Responsive Report of Dr. Todd Kincaid Regarding the Safe Yield Values Proposed by the Indian Wells Valley Water District (IWVWD) and Meadowbrook Dairy

Exhibit 1. Comparison of summed values for the change in groundwater level occurring between 2014 and 2023 as defined by the IWVWD and GSP datasets.

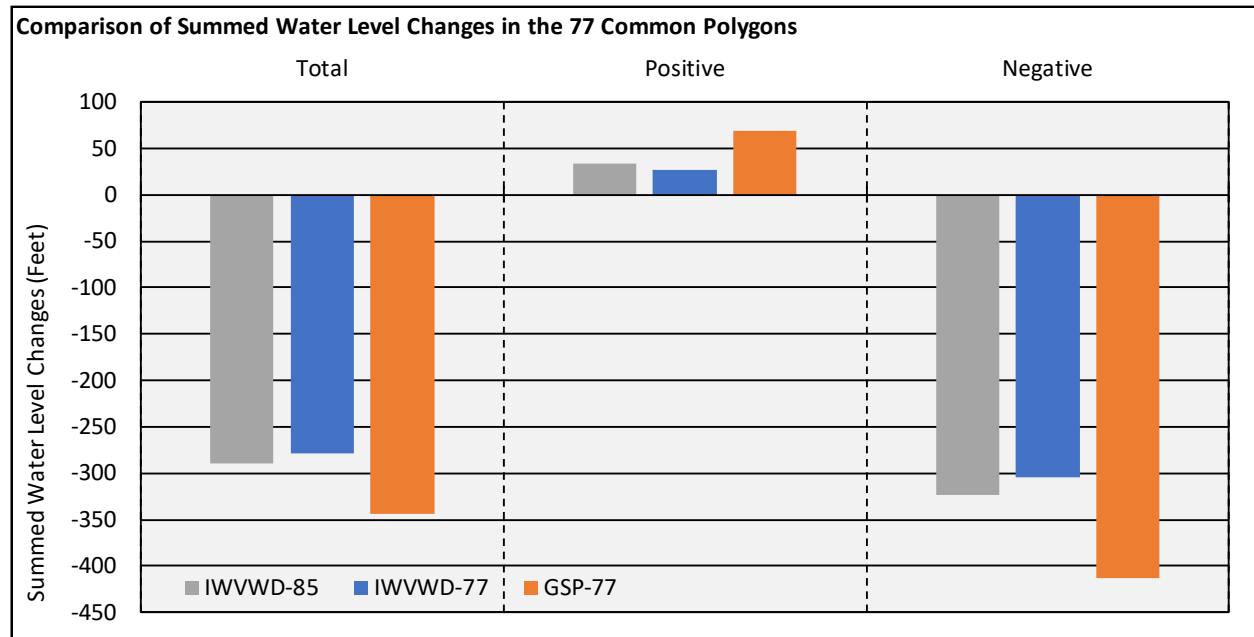
The values reported by both Parker and Teasdale in their 2025 expert reports for the change in groundwater level elevations in the 77 polygons that are common to both the IWWVD-85 and GSP-77 Thiessen polygon sets for the period 2014-2023 sum to a value that is 65.4 feet lower than what is indicated by the data included in the GSP groundwater database. No justification was provided for the lower values and the use of those values result in smaller estimates of the reduction in storage due to pumping by between 23% and 30% of what would be calculated using the GSP values. A map depicting the distribution of the differences between the IWWVD and GSP values for groundwater elevation change for the period 2014 to 2023 is provided on Figure 3. Maps depicting the change in groundwater elevations as depicted by the GSP and IWWVD datasets are provided as Figure 4 and Figure 5 respectively. A comparison of the magnitude of the different datasets for change in groundwater level elevation that occurred between 2014 and 2023 is provided as Exhibit 1. From Exhibit 1, it can be seen that, even after accounting for the eight polygons covering the outer reaches of the IWVGB in the IWWVD's 85 version of the Thiessen polygons, the total reduction in groundwater levels is significantly smaller as defined by the IWWVD's data.

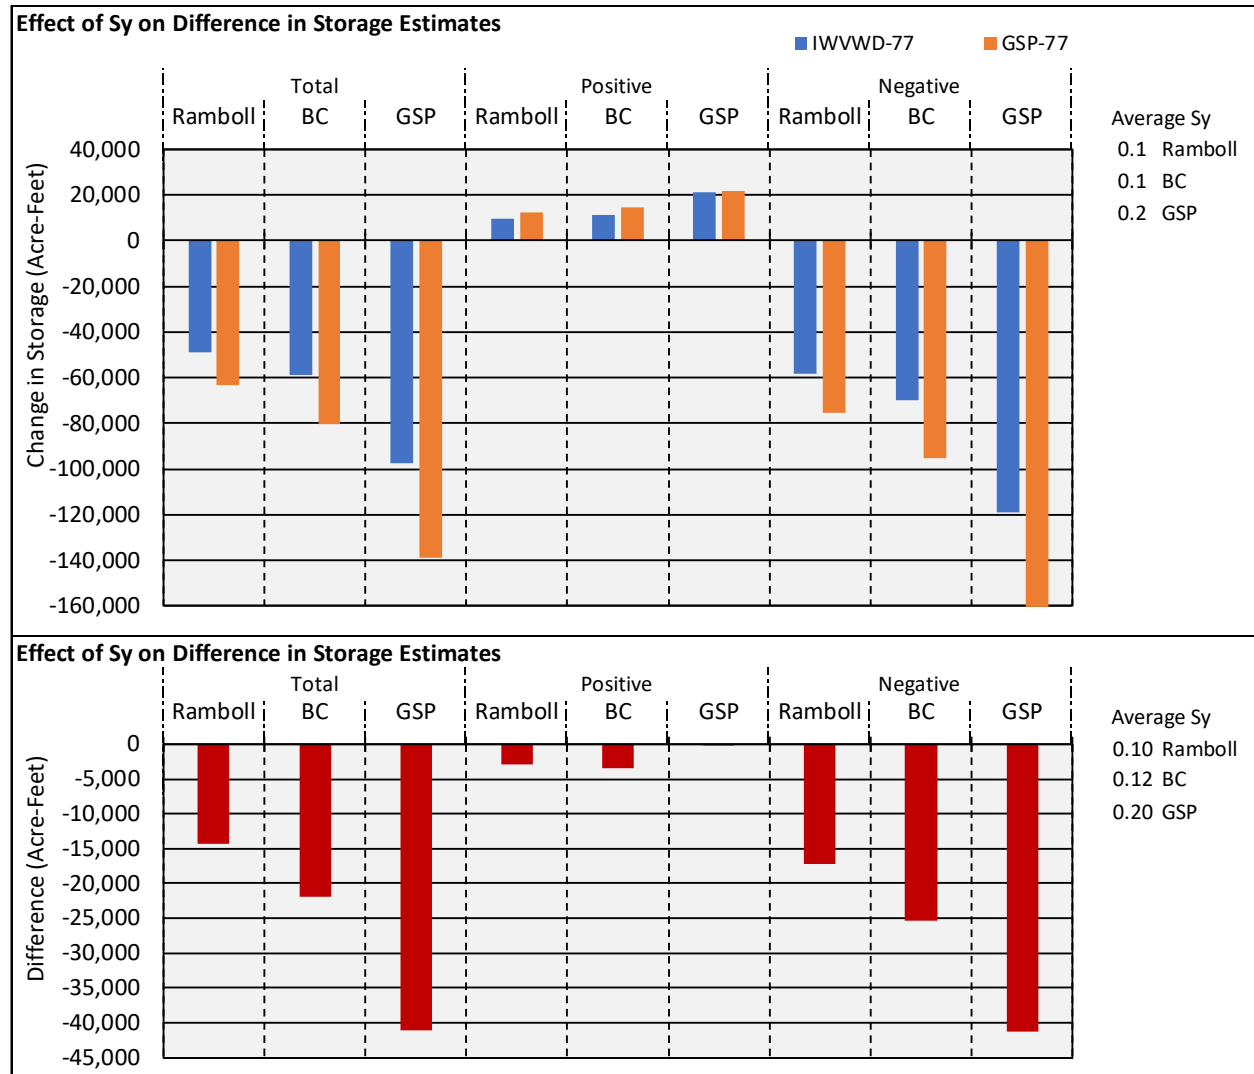
Three different datasets for the spatial distribution of aquifer storage capacity aka specific yield (Sy) have been proposed: two by the IWVWD and one by the GSP. The average values for the 77 polygons shared by IWVWD-85 and GSP-77 Thiessen polygon sets are 0.1 as indicated by the Ramboll groundwater flow model, 0.12 as indicated by the Brown and Caldwell 2009 groundwater flow model, and 0.2 as indicated by the GSP-GWM-2025. All were estimated through groundwater flow modeling. The total calculated reduction in groundwater storage as determined from the two different datasets proposed by the IWVWD and using their data for the change in groundwater levels increases by between 14% and 21% between the lower (Ramboll) and higher (BC) estimates for Sy. When considering the higher GSP-GWM-2025 estimates, the total calculated reduction in storage increases to between 195% and 200% of the calculated values based on the lowest estimates for Sy. Using the GSP version of the groundwater level changes, the range in calculated total reduction in storage rises to 220% when comparing the highest to the lowest estimates for Sy.

The IWVWD’s estimates fail to depict the larger potential reductions in groundwater storage that would have occurred and will continue to occur if the actual aquifer storage capacity is closer to the higher values estimated for the GSP by the GSP-GWM-2025. Exhibit 2 provides bar charts that depict the different estimates of change in groundwater storage as calculated by the different estimates for Sy. The charts show the significance of Sy irrespective of the different groundwater level datasets and show how both the positive and negative changes are impacted as well as the totals.

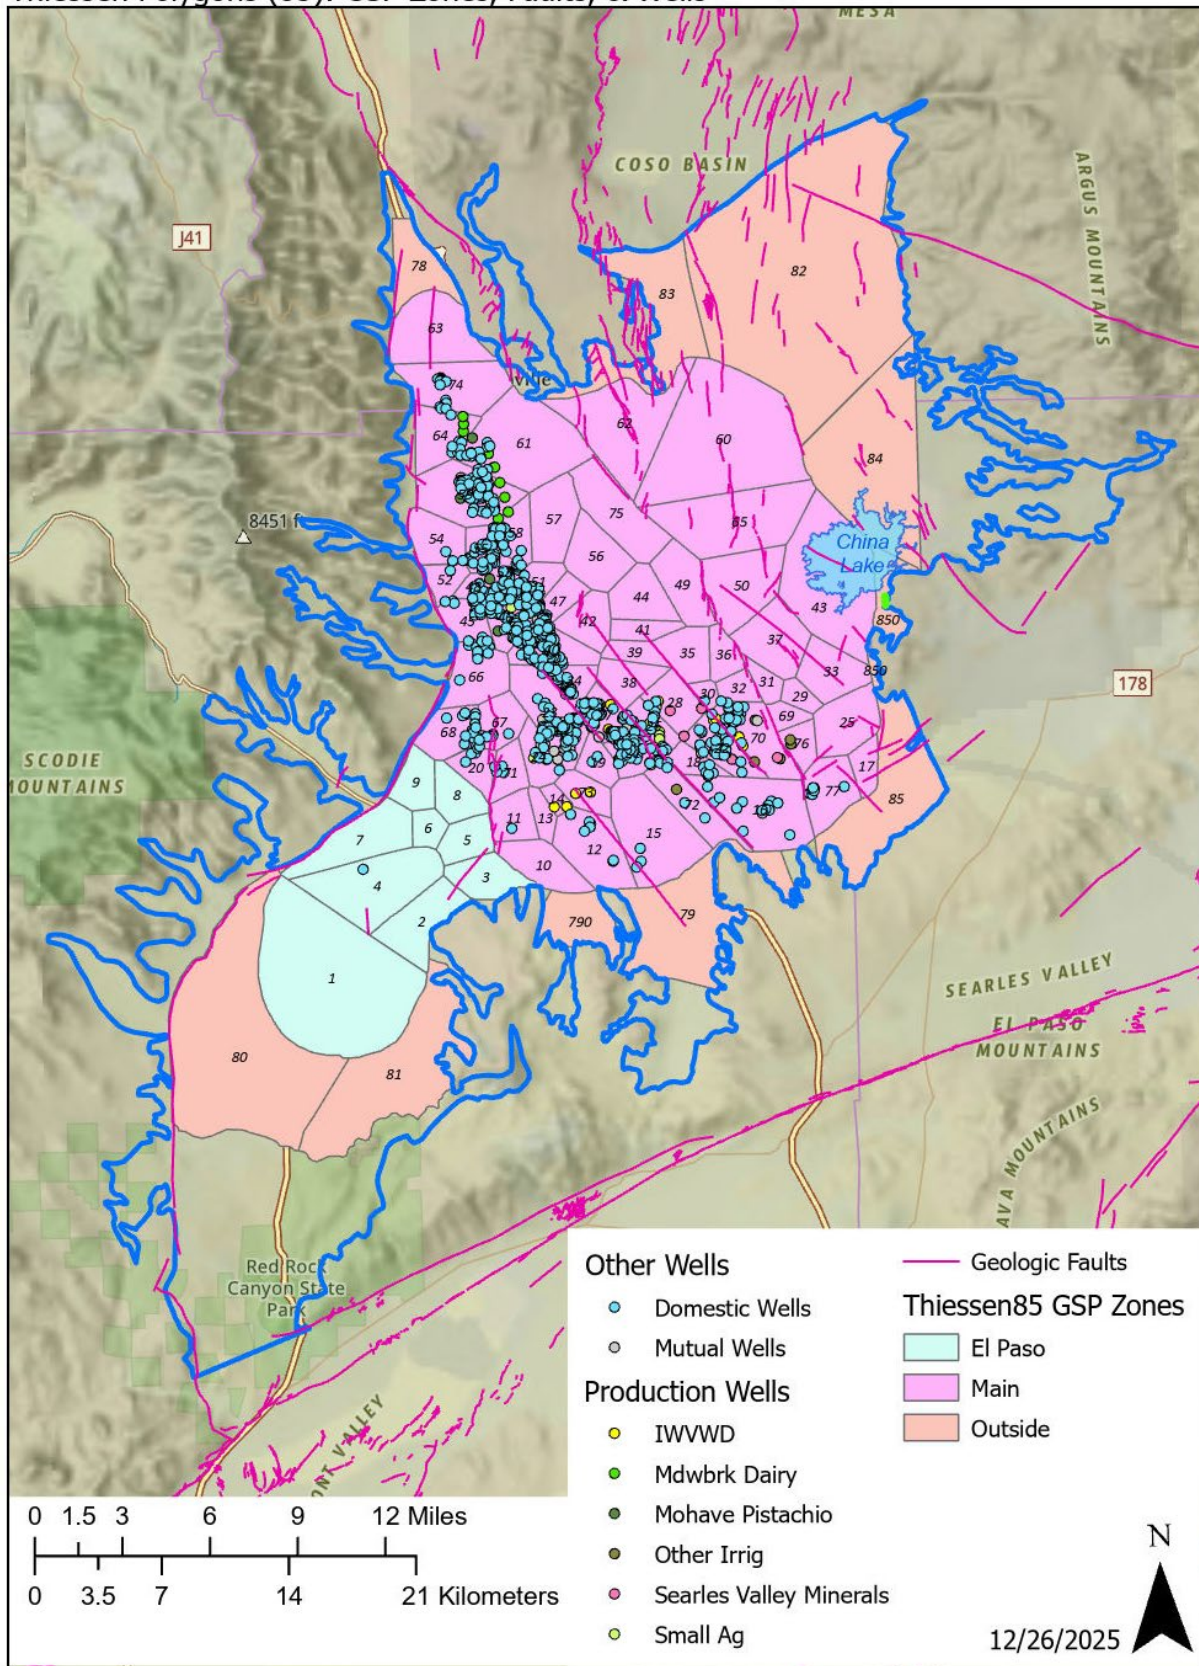
- 1a-1) All but one of the pumping wells are located in what is labeled as the main portion of the IWVGB. Only one domestic well is located within the El Paso portion of the basin (polygons 2-9). Polygons 78-85 cover the outlying portions of the IWVGB.

- 1a-2) The IWWVD's design unreasonably presumes that the pumping affects groundwater levels in all of the polygons and the corollary that recharge to the groundwater system within all of the polygons offsets the drawdown created by pumping.

- 1a-3) The 85-polygon version follows the same boundaries as the GSP version for the 77 polygons that the two versions have in common. Those boundaries largely correspond to the location and orientation of the mapped faults except in the northern part of the basin.

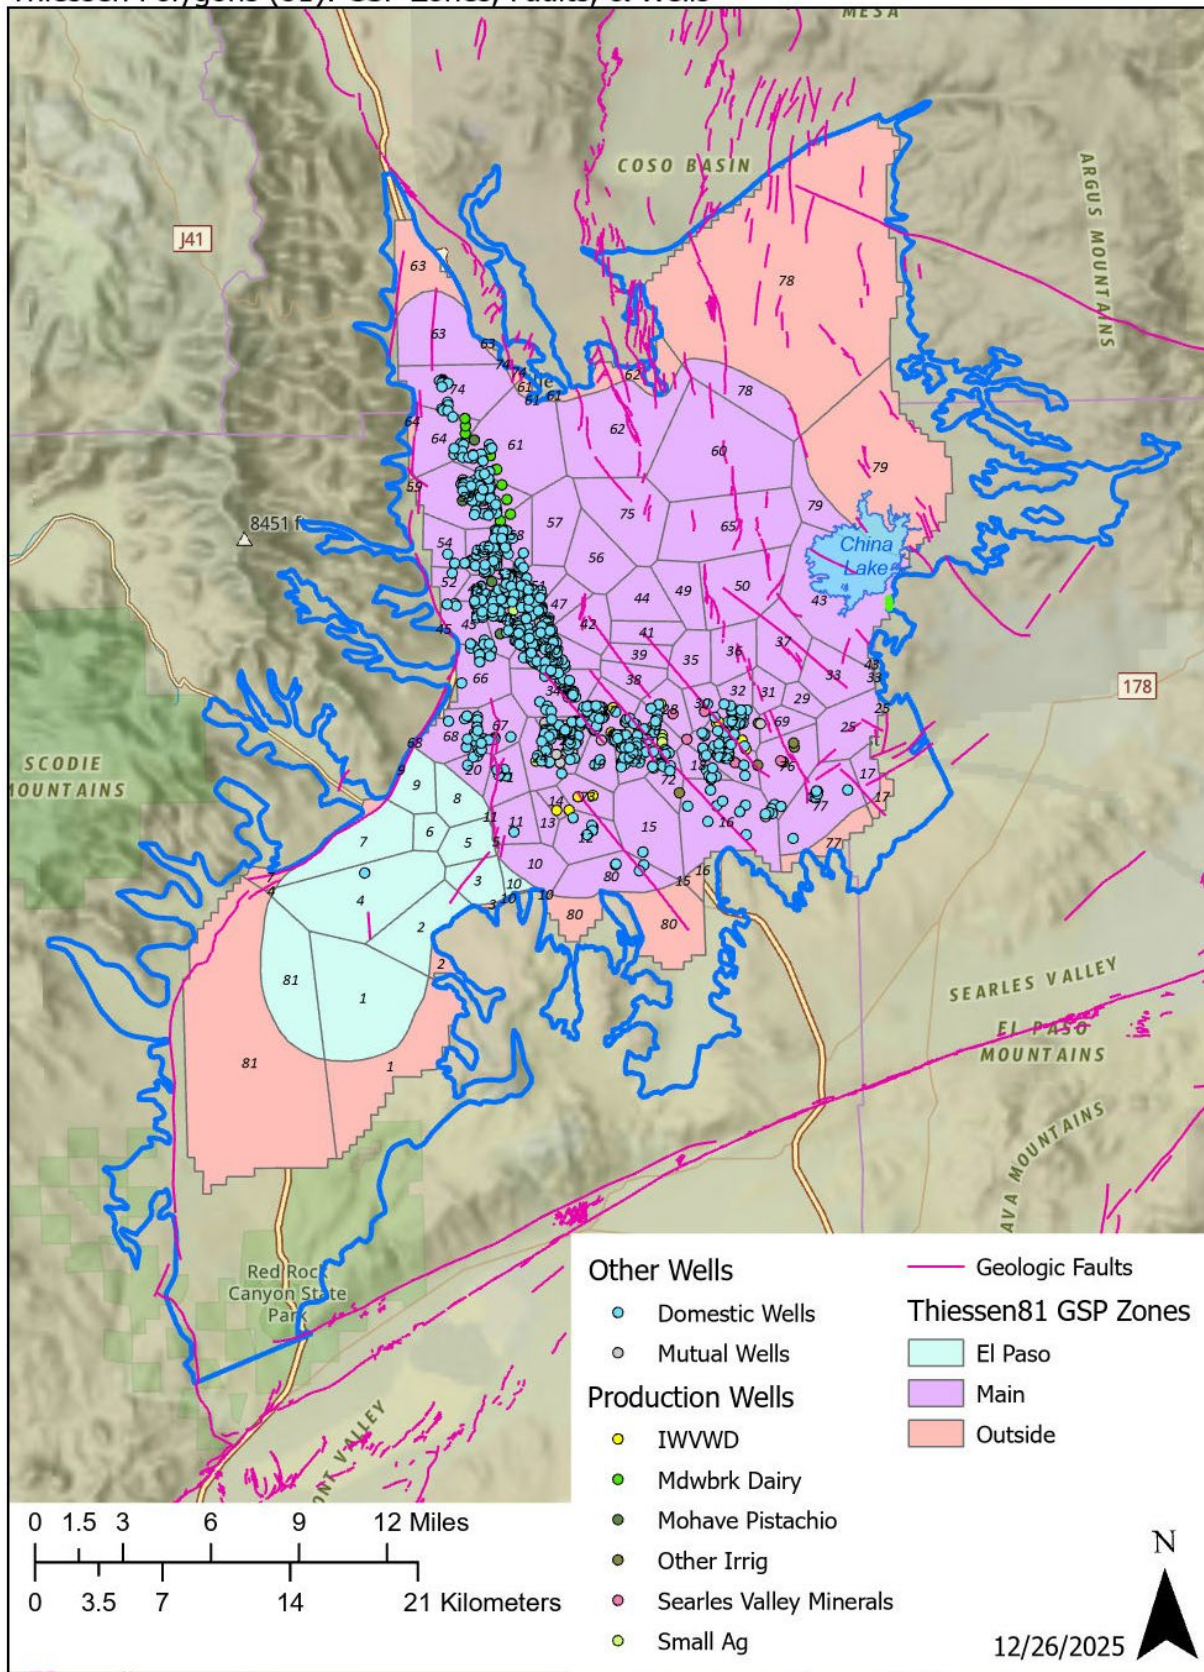
- 1a-4) The boundaries of the polygons in the IWWVD's 81-polygon version deviate substantially from the location and orientation of the mapped faults and is thus less reliable than the 85-polygon version.
